July 28, 2015

SUBJECT: AUDIT REPORT: APPLICABILITY OF 50.46C POST QUENCH
DUCTILITY ANALYTICAL LIMITS TO WESTINGHOUSE
OPTIMIZED ZIRLO™ CLADDING MATERIAL

AUDIT REPORT:
APPLICABILITY OF 50.46C POST QUENCH DUCTILITY
ANALYTICAL LIMITS TO WESTINGHOUSE OPTIMIZED ZIRLO™
CLADDING MATERIAL

Figure 1: WEC PQD RCT Results for ZIRLO and Optimized ZIRLO
(Source: Figure 1 of Reference 1)

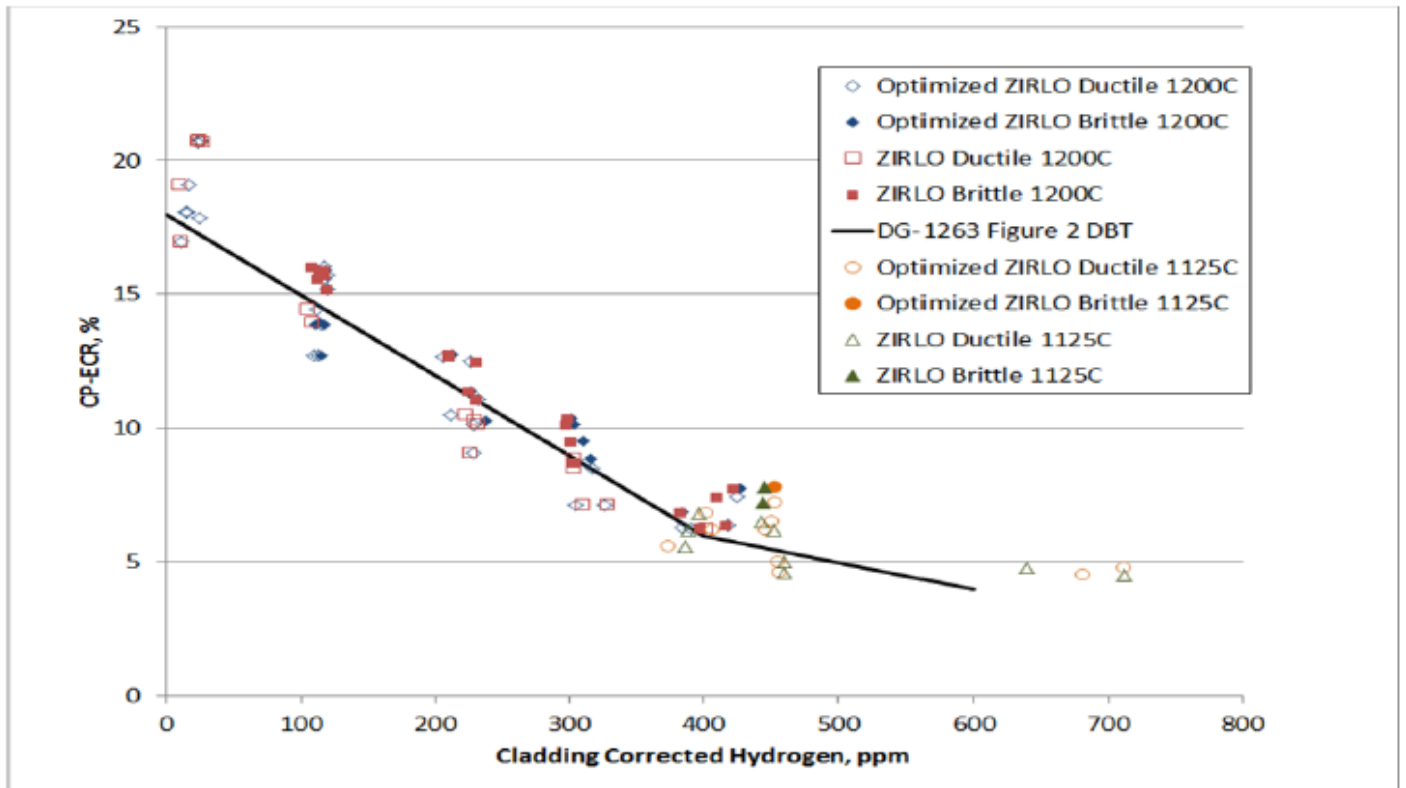
In Reference 1, WEC provides a compilation of the ZIRLO and Optimized ZIRLO PQD database plotted as a function of CP-ECR and cladding corrected hydrogen. Figure 1 shows the extent of the WEC empirical database along with the NRC analytical limit. Plotted are Ring Compression Test (RCT) results for ZIRLO and Optimized ZIRLO cladding in as-fabricated and preloaded with hydrogen to 100, 200, 300, 400 and 600 wppm target levels. Testing was conducted at 1200°C and 1125°C peak clad temperature. Solid symbols denote brittle results and open symbols denote ductile results. Each data point is the average of three ring compression tests with each ring cut from a common specimen of cladding following oxidation and quench. ZIRLO and Optimized ZIRLO cladding specimens were oxidized side by side. Based upon the empirical database, WEC concludes (Reference 1):

The extent of the WEC ZIRLO and Optimized ZIRLO PQD empirical database, shown below, is depicted in Figure 1. WEC has followed the data requirement guidance in DG-1263, which was subsequently reduced in RG 1.224 (draft). The magnitude of Optimized ZIRLO data (i.e., number of tests at each hydrogen level) exceeds the data requirements in current draft guidance and is therefore acceptable.

Figure 2: Combined ANL and WEC PQD RCT Results - ZIRLO

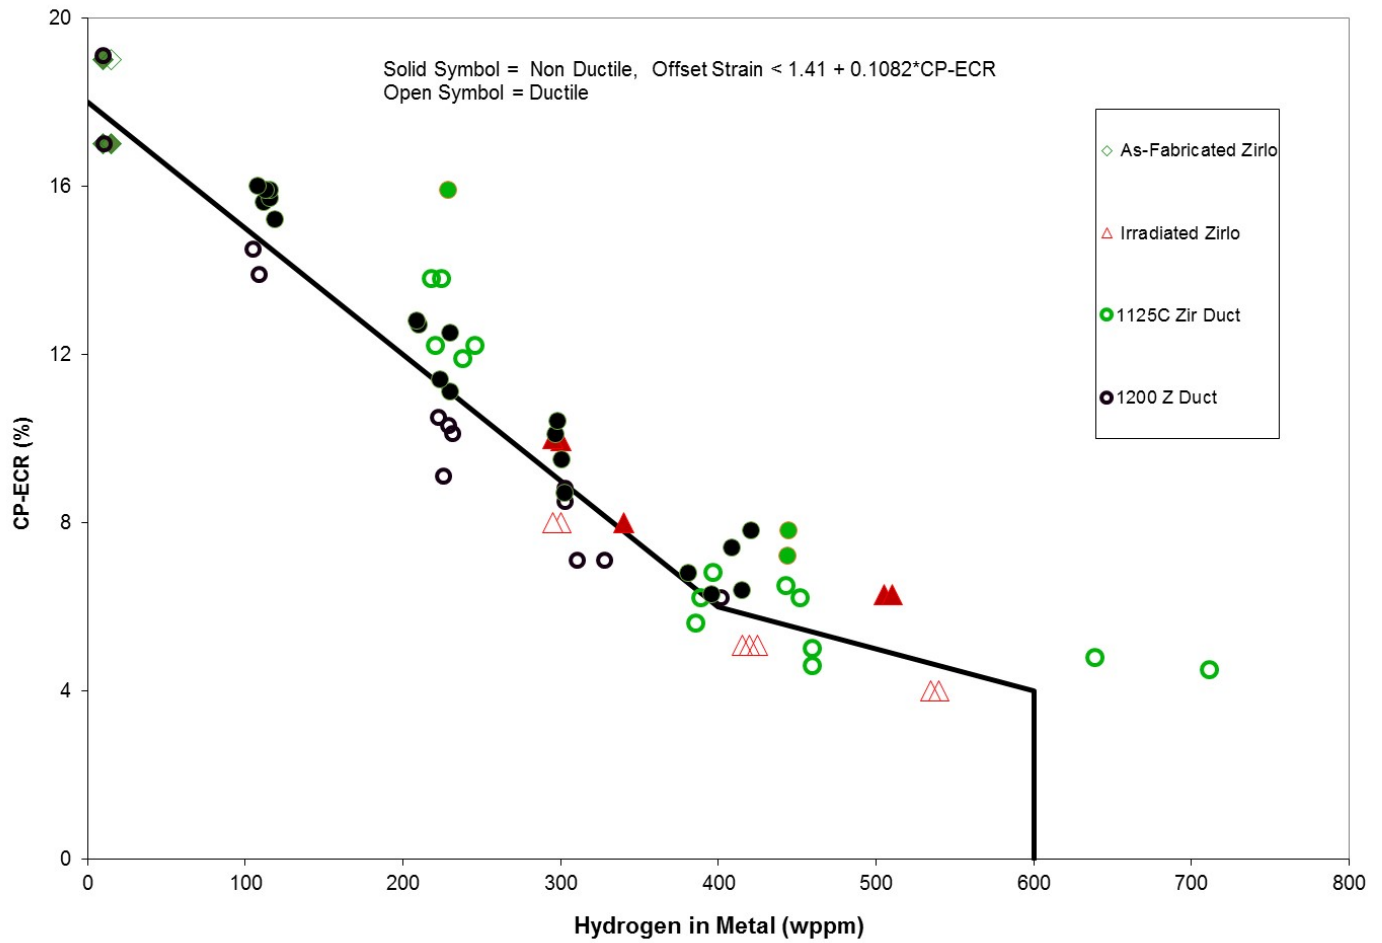
Figure 2 depicts the ZIRLO PQD RCT data from the ANL research program and from the WEC database. Examination of that data reveals good agreement at 300 wppm where common data exists. Note that the ANL data is from irradiated cladding segments, whereas the WEC data is from unirradiated tubing pre-loaded with hydrogen. This comparison provides further assurance that the testing procedures did not introduce a bias in the results nor that testing of irradiated samples were necessary.

Figure 3a: Combined ANL and WEC PQD RCT Results – All Alloys
(WEC Database at 1200°C)

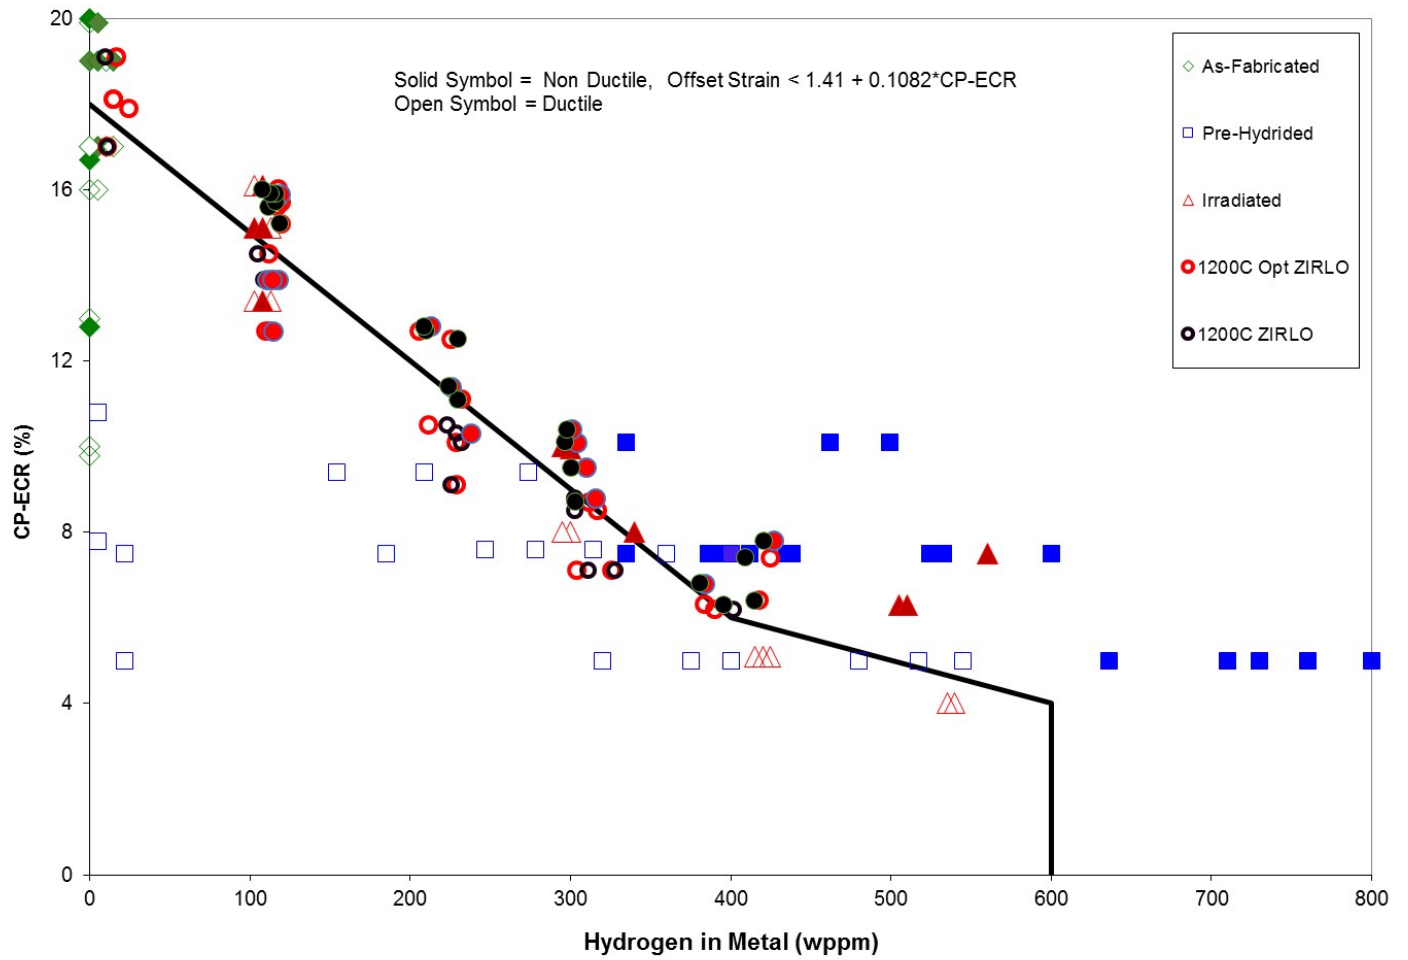
Figure 3a shows the WEC ZIRLO and Optimized ZIRLO PQD RCT database for tests conducted at 1200°C along with the original ANL database. Examination of this figure up to 400 wppm hydrogen reveals the following: (1) the performance of ZIRLO and Optimized ZIRLO is nearly identical, (2) reasonable agreement between ANL and WEC data, and (3) reasonable agreement between DBT as a function of cladding hydrogen for WEC database and analytical limit. Based upon this comparison, the staff finds the Figure 2 (DG-1262) analytical limit applicable to Optimized ZIRLO up to 400 wppm hydrogen.

PQD RCT tests conducted at approximately 100 wppm hydrogen do not exhibit the same definitive DBT as test results at higher hydrogen concentration. Examination of Figure 3a reveals that this is true for both the ANL database (irradiated M5[®] specimens) and the WEC database (hydrogen pre-loaded ZIRLO and Optimized ZIRLO specimens). Ductile and brittle specimens appear on both sides of the analytical limit. Since the acceptable analytical limit was based on a fit of the data, as opposed to a lower bound, this common occurrence of both ductile and brittle test results above and below the line are judged acceptable.
